STAFF REPORT: DECEMBER 13, 2023 MEETING

APPLICATION NUMBER: HDC2023-00143

ADDRESS: 1423 (1425) SIXTH STREET

SCOPE: REPLACE WINDOWS AND VINYL SIDING (WORK COMPLETED WITHOUT APPROVAL)

Staff photo, November 29, 2023.

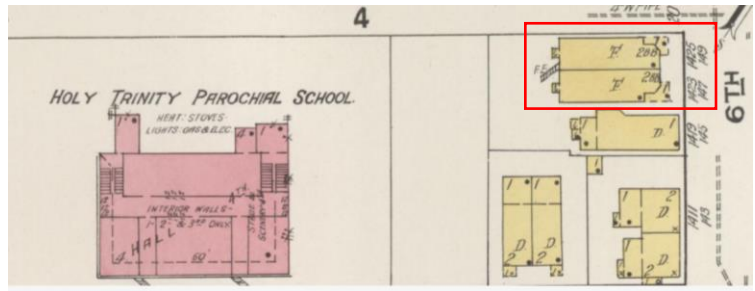
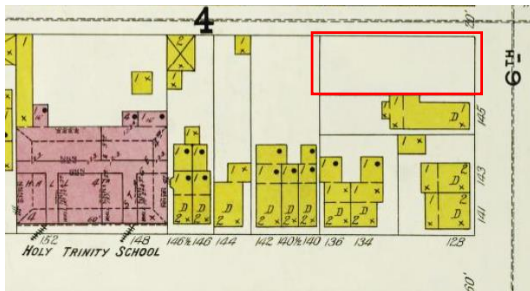
The front walls are clad with narrow wood siding, and wide wood horizontal banding denotes the first and second floors and cornice, which includes elongated dentil trim. The side and rear walls are covered with vinyl siding and window openings are not symmetrically placed. The windows at the front elevation are wood sash, whereas the side and rear elevation windows are contemporary replacement units. The building has a flat roof. The at-grade area at the front of the house is enclosed by a low decorative fence, and a gate opens to a lowered grade where stairs lead down to full-height basement doors.

North elevation, Google street view, October 2020.

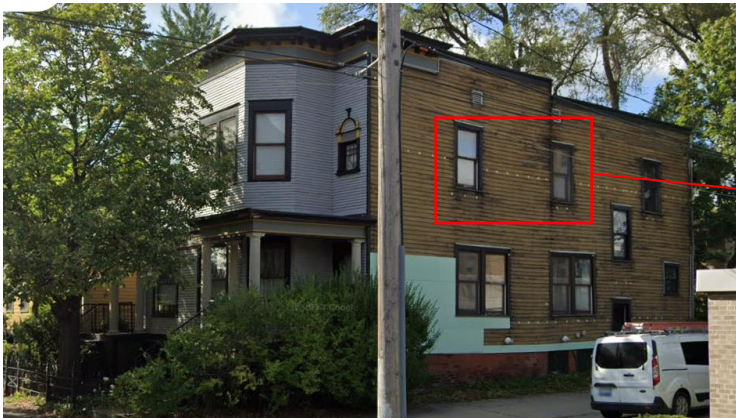
- While vinyl siding was present on the north elevation at time of designation, the historic wood window trim was intact and fully covered. The features and dimensions of the side windows more closely matched those at the front elevation. The 2020 photo shows a similar appearance to the 1984 designation photo (with the exception of the trim being painted black).

- It is staff’s opinion that vinyl siding is not an appropriate replacement product as it does not match the surface texture, reflectivity, finish, edge details, and at times width and reveal, of original wood clapboard siding. Additional details, such as vertical joints in the cladding and protrusion of the siding (either past or in-line with the window casings) further obliterates the “matching” look of wood siding and trim.
- Should the Commission consider the continued installation of vinyl siding at the north wall, the aluminum wrap over the window casings should be removed and the historic wood window trim be re-exposed to match the wall condition that was present at time of designation.
